**CENTER FOR DRUG EVALUATION AND
RESEARCH**

761219Orig1s000

MEMORANDUM
HUMAN FACTORS STUDY RESULTS AND LABEL AND LABELING REVIEW MEMO
Division of Medication Error Prevention and Analysis 1 (DMEPA 1)
Office of Medication Error Prevention and Risk Management (OMEPRM)
Office of Surveillance and Epidemiology (OSE)
Center for Drug Evaluation and Research (CDER)

REVIEW OF REVISED LABEL AND LABELING

can be overlooked.  <i>Figure H</i>	Additionally, we recommend revising the image in Figure H to make it clear that it is the FDA cleared sharps container.

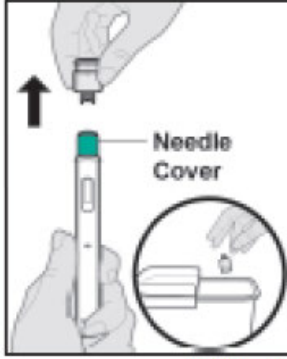
6.	The instruction to dispose of the cap in Step 8 and the image in Figure H are not prominent.	We are concerned that due to the formatting of the text in Step 8, instruction to dispose of the cap	We recommend revising the IFU Step 8 to make the instruction to dispose of the cap more prominent, for example by including it as a separate bullet, or some other means.
